Administration

This is to notify you that our office has approved your airport layout plan marked FINAL February 2011 with revision and accepted the *Airport Master Plan Update Report* draft dated May 2009, subject to the following comments and conditions and revisions.

BETHEL REGIONAL AIRPORT

BETHEL AIRPORT MASTER PLAN UPDATE AIP Project No. 3-23-0008-10-2009

Attached drawing of pen and ink revision approved by this letter,

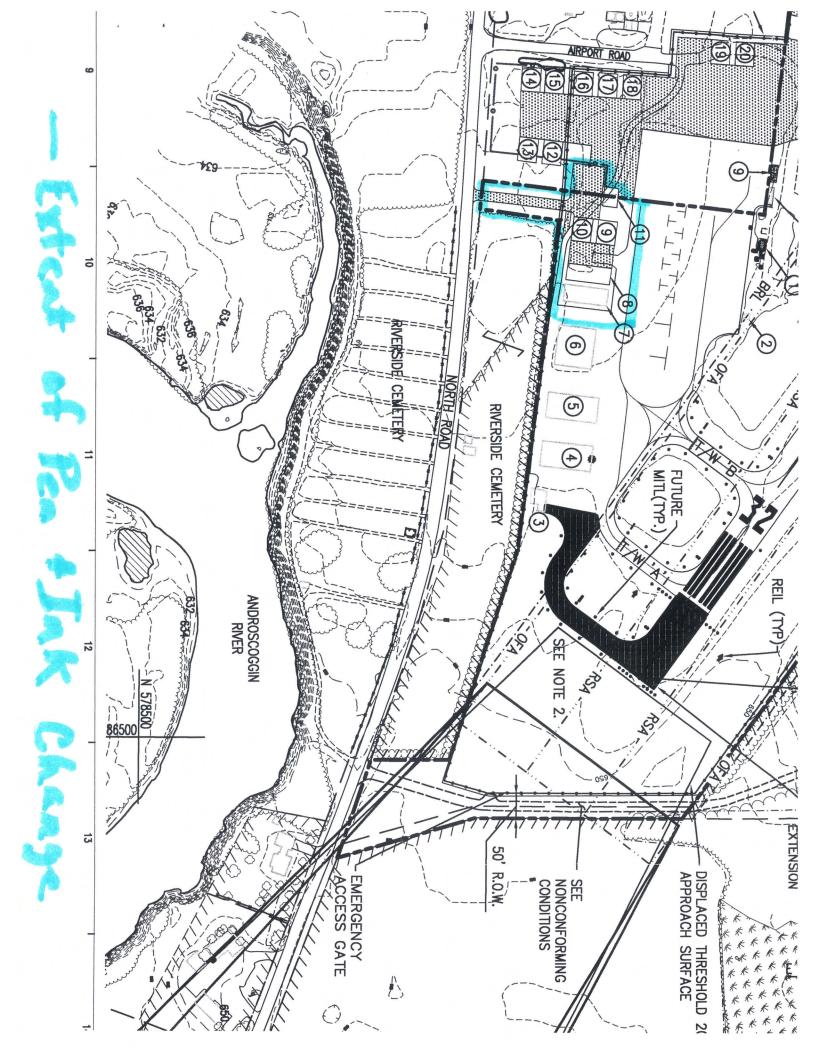
To resolve this transition I am approving a pen and ink change (see attached drawing) to the May 2009 plan to include the following portions of Stantec's proposed revision:

- Hangar 7 should be shown as "existing".
- Hangars sites 8,9 and 10 are approved subject to airspace review (FAA Form 7460)
- Terminal Building 11 and associated auto parking lot and driveway access to North Road. The existing terminal building should be shown as "to be demolished" with proper restoration of the site.
